Product Change Notification - SYST-15YXLG147

Date: 23 Aug 2017
Product Category: Ethernet Switches
Affected CPNs:  
Notification subject: ERRATA - KSZ9477S Silicon Errata & Data Sheet Clarification Errata Document Revision
Notification text: SYST-15YXLG147

KSZ9477S Silicon Errata and Data Sheet Clarification

FIGURE 1: IEEE DOCUMENT PAGE 6

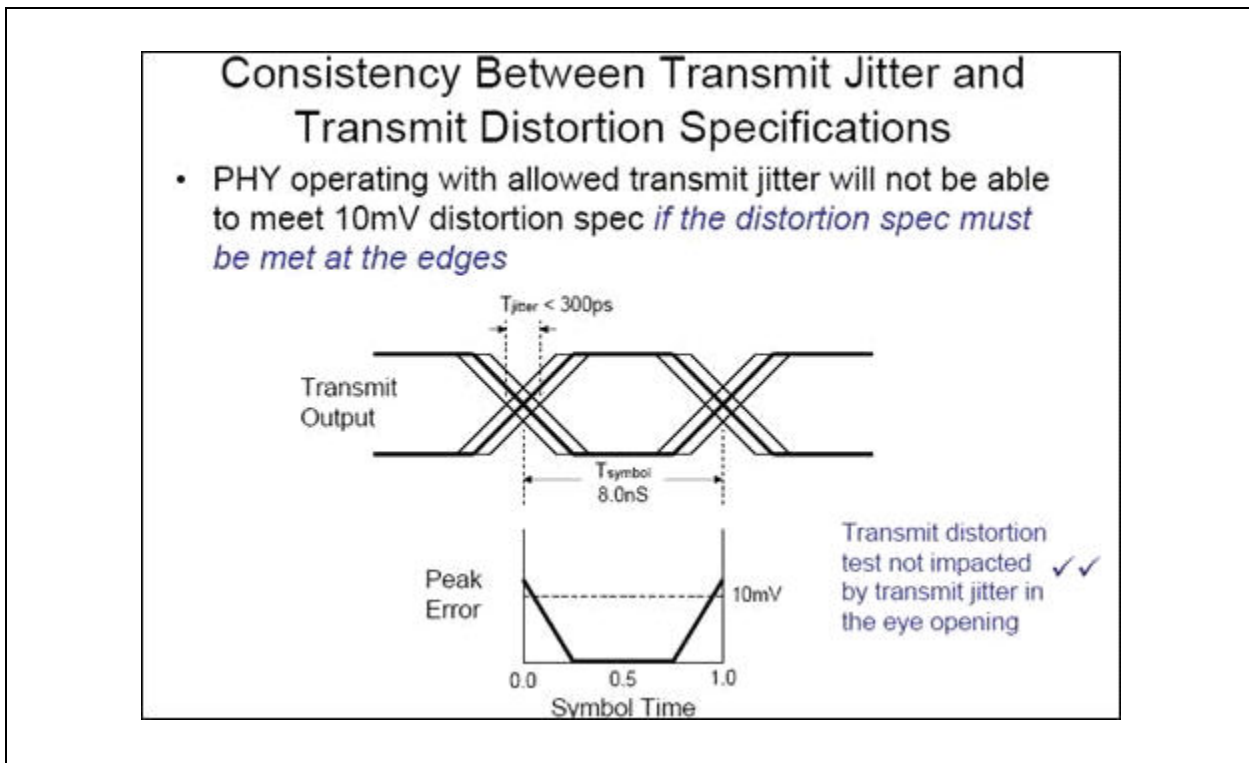
The device's 1000BASE-T Transmitter Distortion is approximately 40mV, versus the <10mV indicated in the IEEE specification.

IEEE testing calls for <10mV peak transmitter distortion for at least 60% of the UI within the eye opening. However, this measurement might not be valid, as the transmit distortion test is sensitive to transmit jitter. Refer to the explanation below, taken from the aforementioned IEEE document.

- On page 6, a contradiction between Transmit Jitter and Transmit Distortion requirements:

None.

FIGURE 2: IEEE DOCUMENT PAGE 7

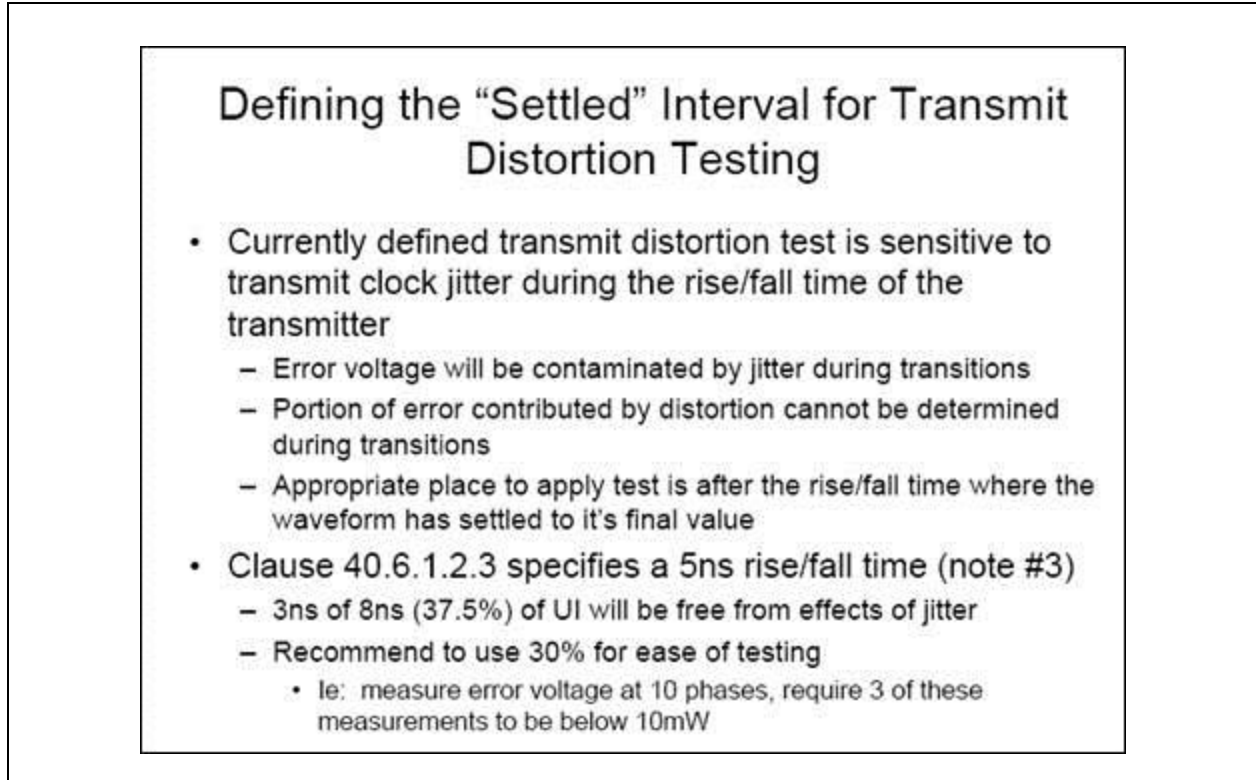
- On page 7:
 - The transmit distortion test is sensitive to transmit clock jitter during the rise/fall time.
 - It is recommended to change the requirement to use at least 30%, instead of at least 60%, of the UI within the eye opening for the <10mV peak transmitter distortion.
